**CITY OF MENASHA
Board of Public Works
Third Floor Council Chambers
140 Main Street, Menasha
October 18, 2010
Special Board of Public Works Meeting
5:50 PM**

CHANGE ORDER REQUEST

JOB #:101520
MOD #: 0005 -00
DATED: 10/15/10

RE: Neenah Menasha Fire
Rescue Station 36
1108 Province Terrace
Menasha WI 54952

APPROXIMATE FIELD TESTING LOCATIONS DIAGRAM	Scale: 1" = 40'
	Project No:
MENASHA FIRE STATION MANITOWOC ROAD MENASHA, WISCONSIN	Date: 10/14/10
	Drawn By: KP

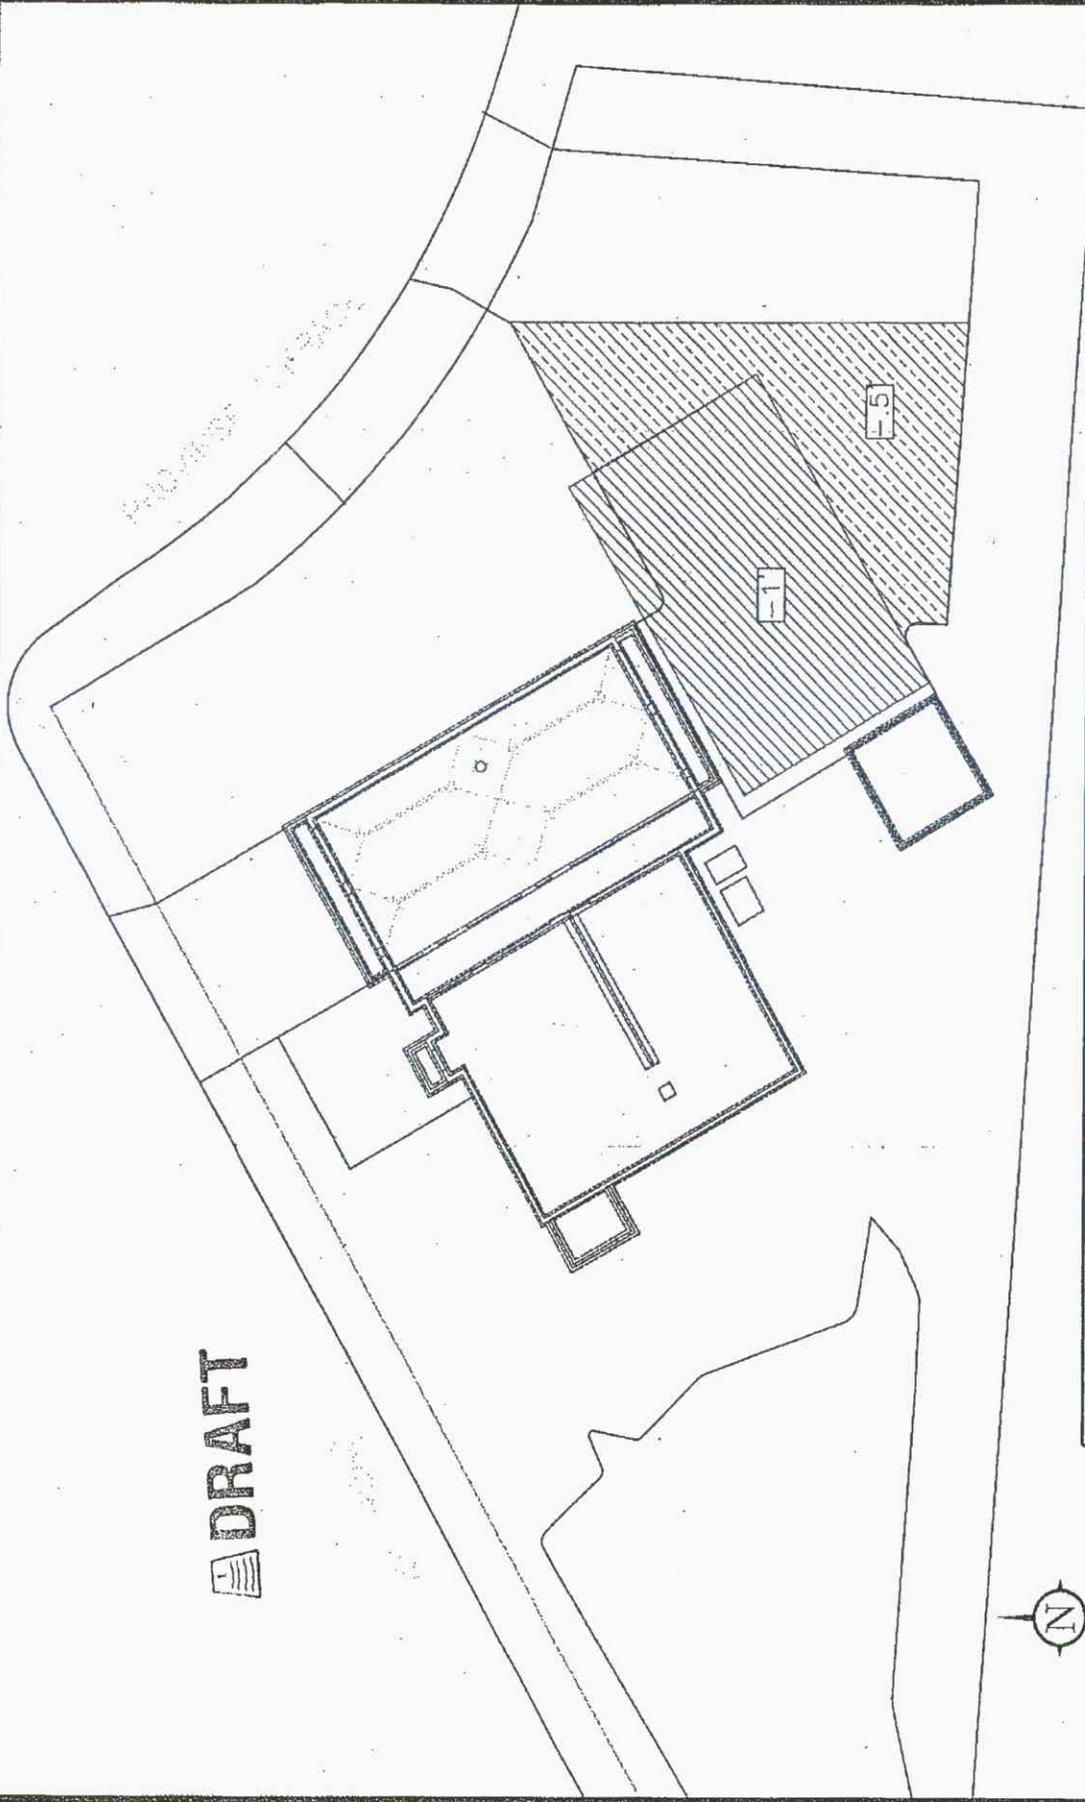
Major rolling and rutting was observed during proofroll in a area 50'x80'. MES recommended removing 1' of material and replacing it with compacted 3 inch breaker. Minor rutting and rolling was observed within the remaining area of the parking lot. Within this area, MES recommended removing 6 inches of material and replacing it with compacted 3 inch breaker. It is also recommended that fabric be placed prior to placing stone.

Remove and replace unsuitable soils at asphalt parking area per MES Soils Engineer recommendation. Also provide segregation fabric. Use unit prices.
